Re: Appeals of Planning Commission Decision No. 20-**** dated November 18,
2020; MB Hotel Partners, LLC Proposed Hotel, Retail and Office Project at 600
S. Sepulveda Boulevard

Subject: Response to Traffic and Parking Comments – Manhattan Beach Hotel Project
600 S. Sepulveda Boulevard, Manhattan Beach, CA

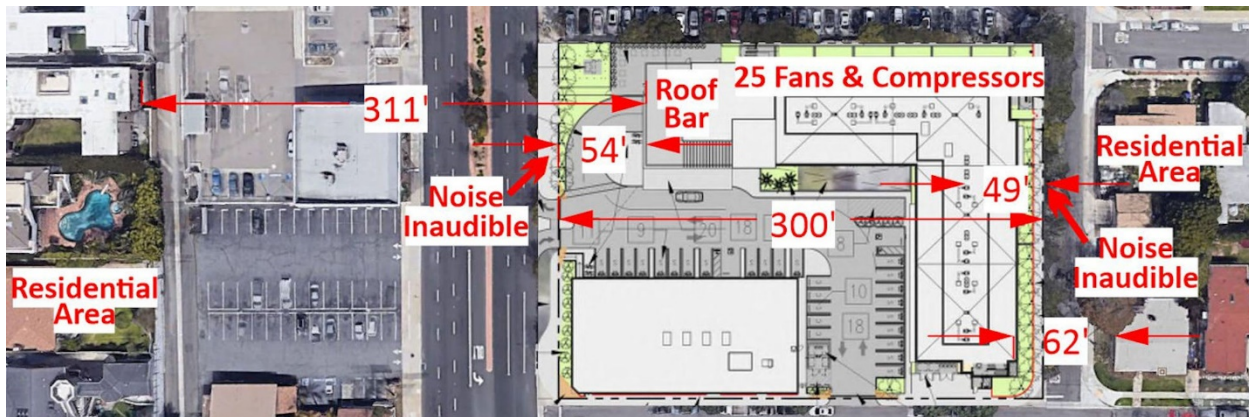
The 600 PCH traffic analysis excluded residential streets nearby the project, by not considering their intersections with the major arterials, Sepulveda and Artesia, as illustrated in the lower half of the map. [Ibid.]

Based on Mr. Neustaedter's review of the 600 PCH traffic analysis, he states, "However, the study does not address potential impacts to the adjacent residential neighborhood." [Ibid., p. 141]

PROJECT PLANS DEPICTING GARAGE MEANS OF EGRESS AND NORTH STAIR

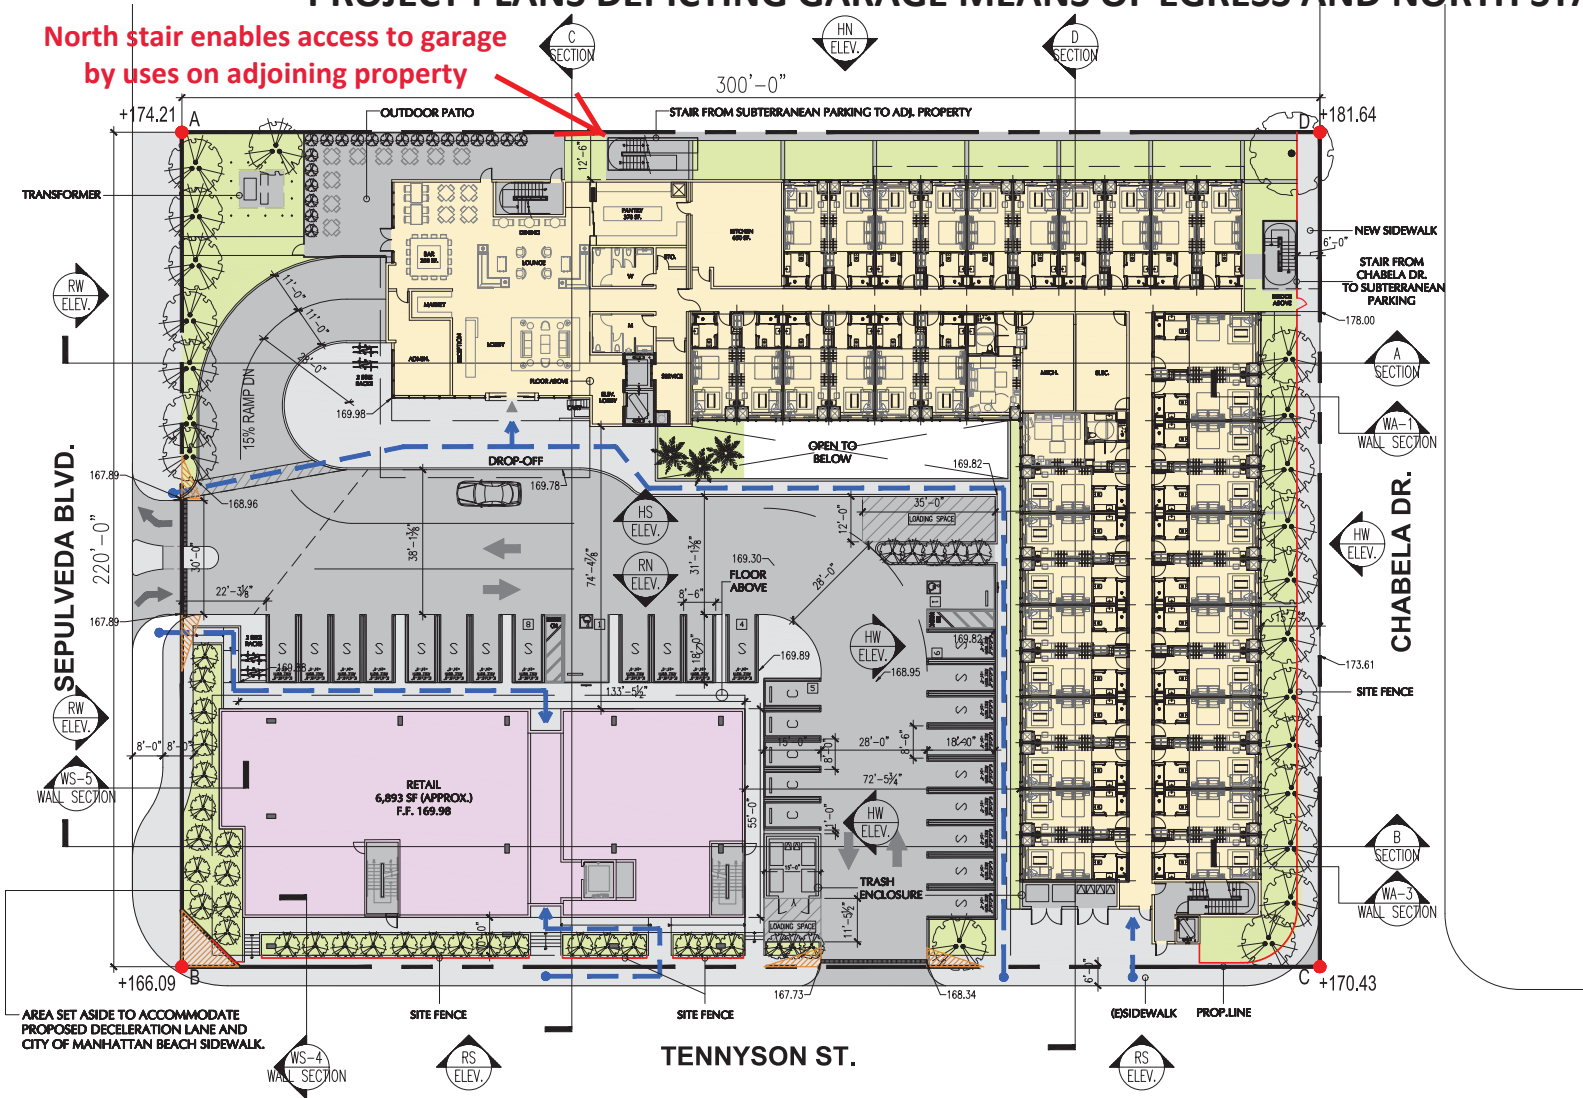
Neither of the answers above correct in response to Mr. Thompson's request for a condition that prohibits garage parking by external users on the adjoining north property. Per architect Michael Rendler's letter, Exhibit 6, p. 108:

North stair enables access to garage by uses on adjoining property

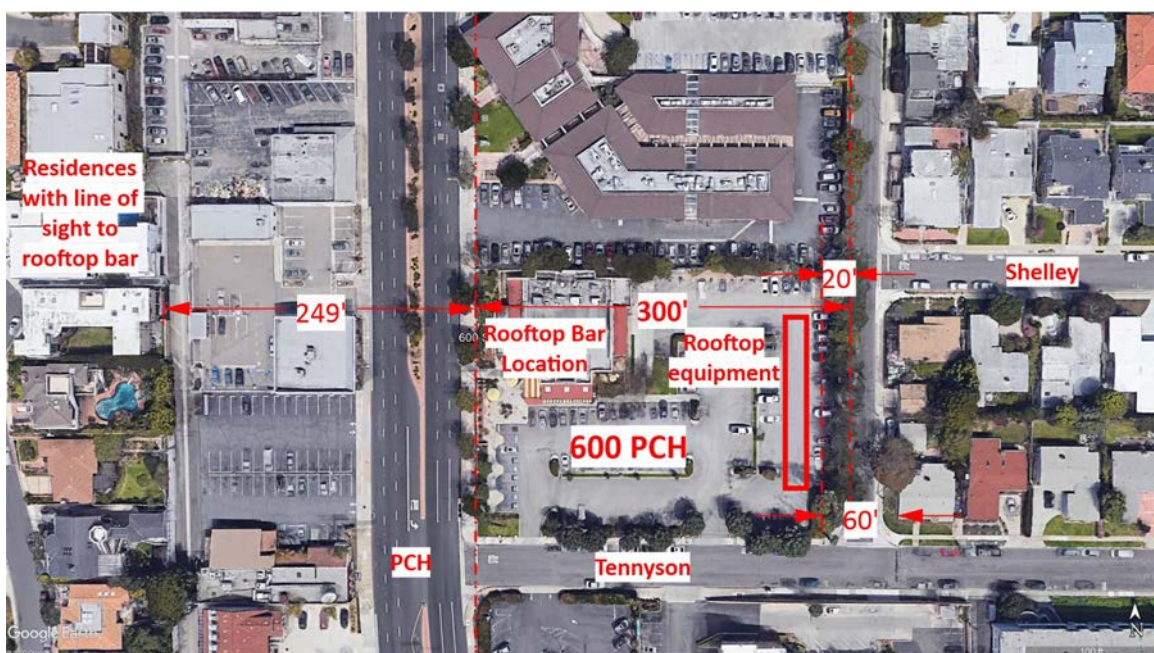
The 600 PCH traffic analysis deleted residential streets nearby the project, by excluding their intersections with the major arterials, Sepulveda and Artesia, as illustrated in the lower half of Exhibit 3.

Based on Mr. Neustaedter's review of the 600 PCH traffic analysis, he states, "However, the study does not address potential impacts to the adjacent residential neighborhood." [Exhibit 5, p. 2, 1st para.]

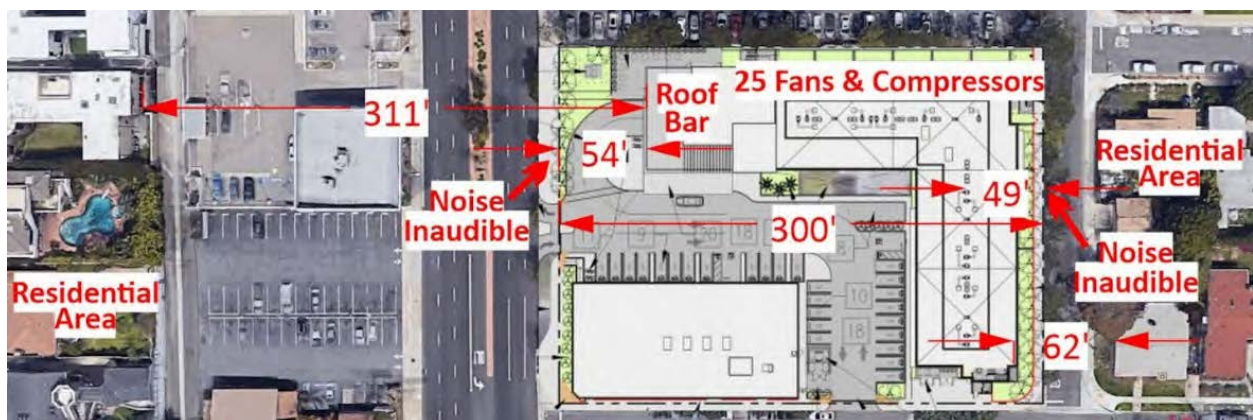
The 600 PCH traffic analysis excluded residential streets nearby the project, by not considering their intersections with the major arterials, Sepulveda and Artesia, as illustrated in the lower half of the map. [Ibid.]

Mr. Neustaedter states, "However, the study does not address potential impacts to the adjacent residential neighborhood." [Ibid., PDF p. 83]

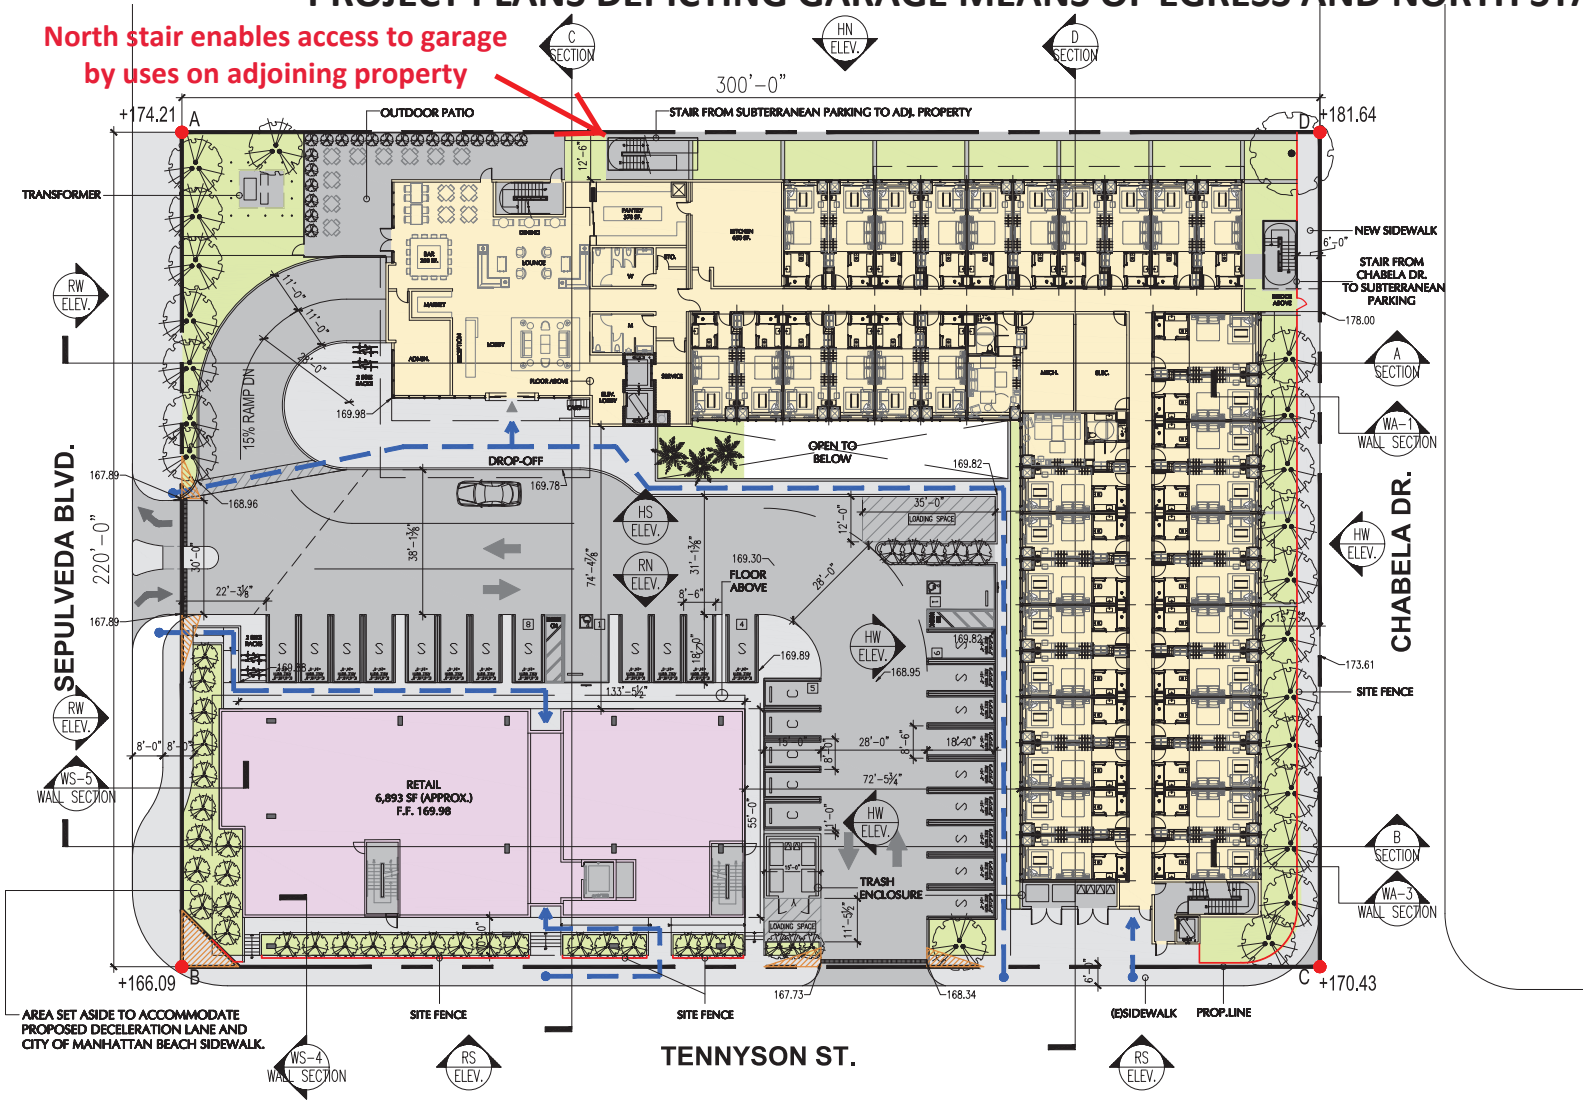
North stair enables access to garage by uses on adjoining property

Figure 1: Marked-up excerpt from the September 29, 2020 drawing set showing the number of pieces of HVAC equipment proposed for the hotel roof

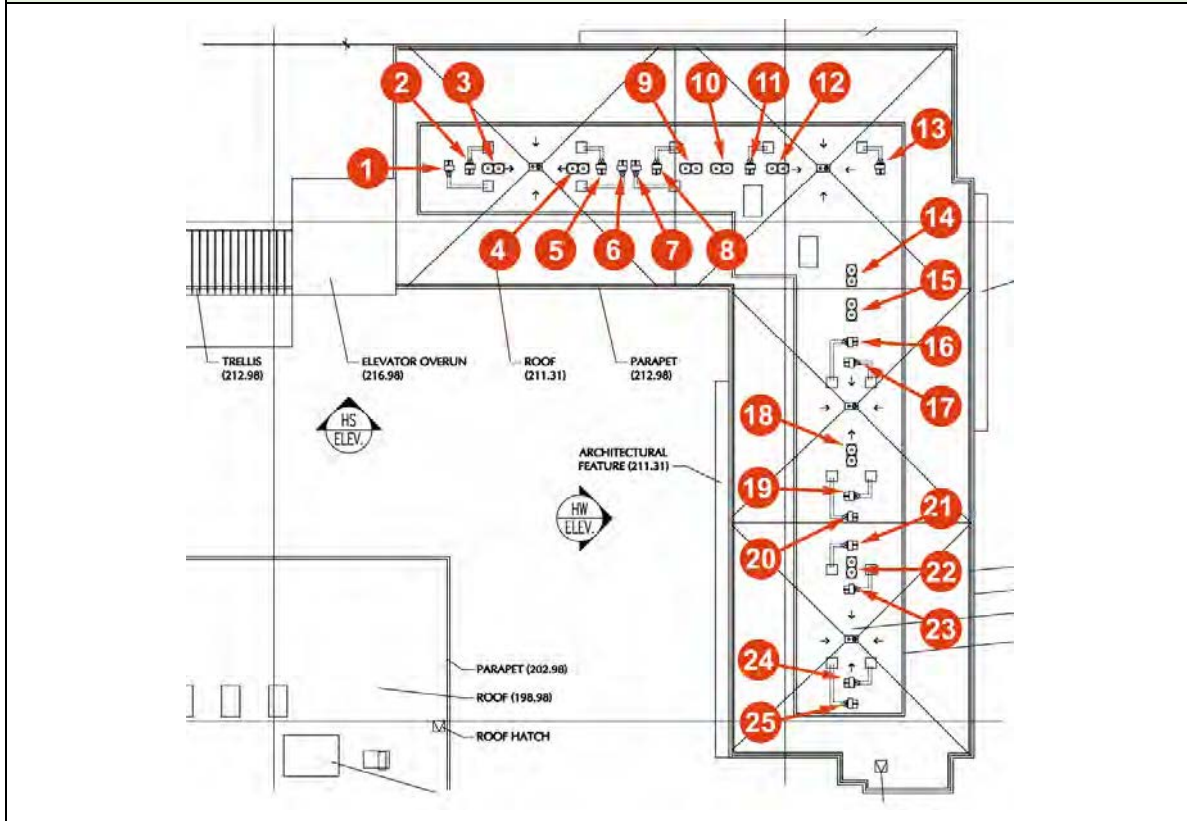
- To address the first issue, the January 14, 2021 Staff Report states (at the top of page 9) that "the project proposes only 11 HVAC units". This is not true. According to the project drawing set dated September 29, 2020, a total of 25 pieces of HVAC equipment are proposed for the roof of the building (9 condensing units and 16 fans), as shown in Figure 1.
